August 2, 2010

SUBJECT: Tentative Order No. R5-2010-XXXX, Amending Waste Discharge Requirements
Order No. R5-2007-0132-02 (NPDES Permit No. CA0079049)

Figure 1. Season 1 Temperature at R-2

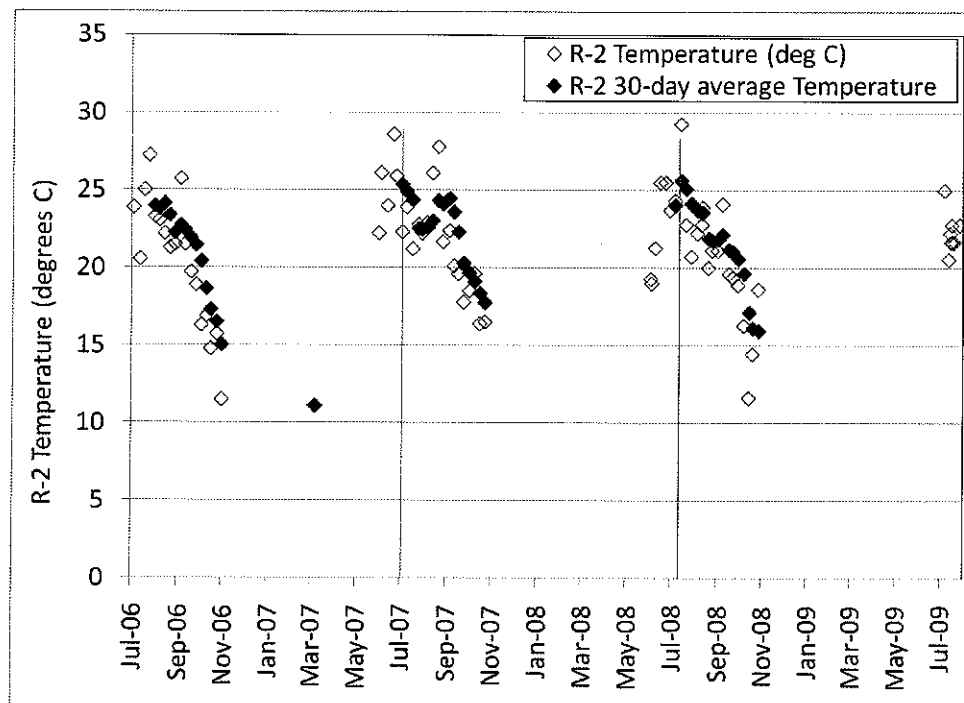
Further, receiving water data indicate that the ambient conditions directly correlate to the limiting factors for each season. For example, the temperature component of the CCC equation drives the lowest CCC during season 1. During season 1, the highest (most limiting) temperatures measured at R-2 occurred during the months of July, as shown in Figure 1. In July, there is water in the Toe Drain due to agricultural runoff. Thus, temperatures at R-2 are not reflective only of effluent and are influenced by agricultural runoff from upstream, which is outside of the City’s control.

Due to the variability of ambient conditions and the lack of dilution, the City contends that effluent limits for ammonia should not be based on temperatures elevated by agricultural runoff, nor on pH levels collected during times of low flow and stagnant water. Instead, ammonia effluent limits for Discharge 001 should be based on the effluent pH and temperature conditions and set equal to the values shown in Table 1.

Figure 2. Season 2 pH at R-2

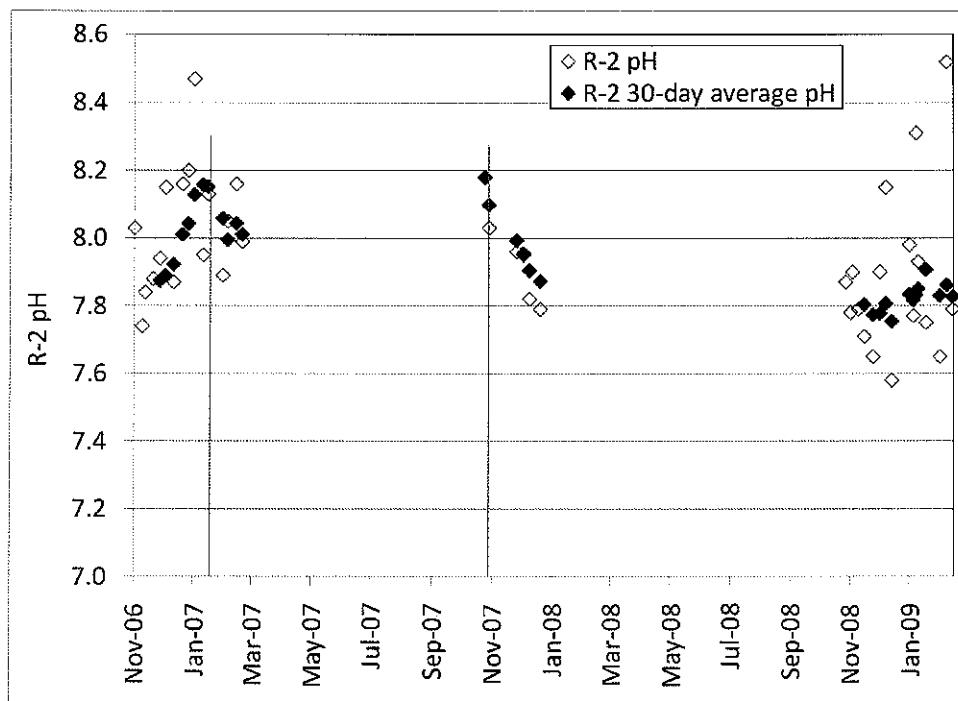
The receiving water data also shows that the pH component of the CCC equation drives the lowest CCC during season 2. The highest (most limiting) season 2 pH values measured at R-2 occurred during the months of November and January, as shown in Figure 2. Specifically, in January 2007, very low flows were calculated for R-1 (0.5 – 1 mgd), and three beaver dams were observed downstream. Due to the low upstream flows and the beaver dams, downstream water stagnated, which resulted in higher pH values.
